**QUALITY ASSURANCE -- NON-CONFORMANCE REPORT**

**Location:** Changxing Island, Shanghai, PRC **Report No:** NCR-000434  
**Prime Contractor:** American Bridge/Fluor Enterprises, a JV **Date:** 28-Sep-2009  
**Submitting Contractor:** Zhenhua Port Machinery Company, Ltd (ZPMC), Changxing Island **NCR #:** ZPMC-0408

**Reference Description:** Missed MT Indications on East Tower, Lift 1 Padeyes

**Dear:** Mr. Charles Kanapicki  
**Job Name:** SAS Superstructure

项目名称 Project Name:	美国海湾大桥 SFOBB	部件图号 Drawing No.:	ESD1-A167A/H	报告编号 Report No.:	T-CWR314
合同号 Contract No.:	04-0120F4	部件名称 Item Name:	东塔一吊AB面吊环 First lifting Tower (E) Skin AB lifting	NDT 报告编号 NDT Report No.:	NA
项目编号 Project No.:	ZP06-787

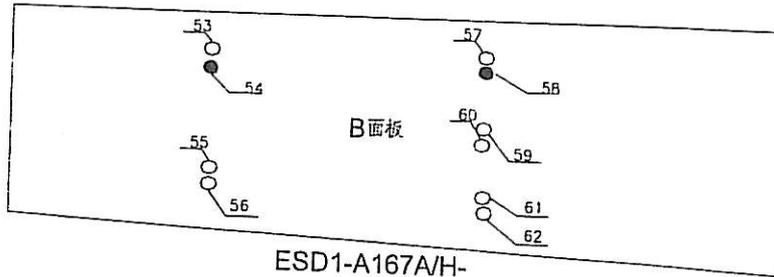
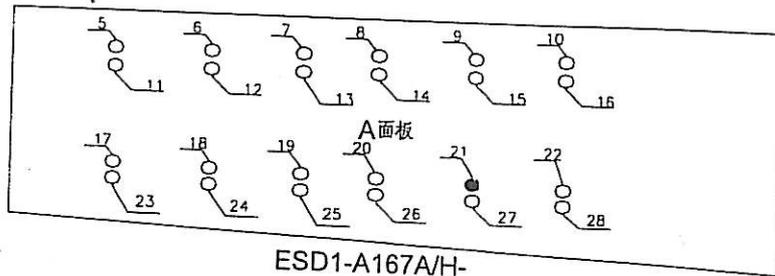
东塔一吊A面1个吊环B面2个吊环MT后发现裂纹:

A面: ESD1-A167A/H-21

B面: ESD1-A167A/H-58 54

Cracks were found at first lifting Skin A and Skin B, relevant weld No.:

Skin A: ESD1-A167A/H-21;

Skin B: ESD1-A167A/H-58 54

1. 火焰加热时, 水汽没有完全的去掉或者这个区域预热不够;

1. Moisture wasn't completely removed during drying operation (preheating) or the area wasn't preheated sufficiently.

1. QC shall monitor and direct the welder and the grinder doing the repair operation.
2. Preheat before gouging; the temperature shall be at least 65°C.
3. Gouge the weld to remove identified defects.
4. Joint details shall refer to the approved WPS repair.
5. Grind the gouged areas to a smooth and shiny surface.
6. Verify with VT and MT to ensure no defects remain in the weld joint prior to welding.
7. QC shall monitor all welding passes being deposited.
8. QC shall ensure all slag has been removed prior the deposition of next pass.
9. Preheat and maintain interpass temperature control in accordance with the WPS.
10. Blend the weld repaired areas into the adjacent weld or base metal by grinding.
11. Perform VT, MT and other NDT inspection to the repaired areas.

- 1、在返修过程中, QC 应该监控和指导焊工和打磨工;
- 2、碳刨之前必须先进行预热, 温度不低于 65° C;
- 3、碳刨去除缺陷;
- 4、缺陷被完全消除后, 必须准备一个正确的接头型式, 具体接头型式请参见对应的修补焊接工艺规程(WPS);
- 5、将碳刨面打磨光滑;
- 6、在准备好焊接接头焊接前, 用 VT 和 MT 检测缺陷被完全清除;
- 7、在返修过程中, QC 确认焊道清理干净;
- 8、在进入下到焊缝前, QC 应该保证所有的缺陷已经去除,
- 9、根据 WPS 控制预热和焊道的温度;
- 10、打磨返修区域与临近焊缝和母材其平;
11. VT,MT和其它NDT检测焊缝。
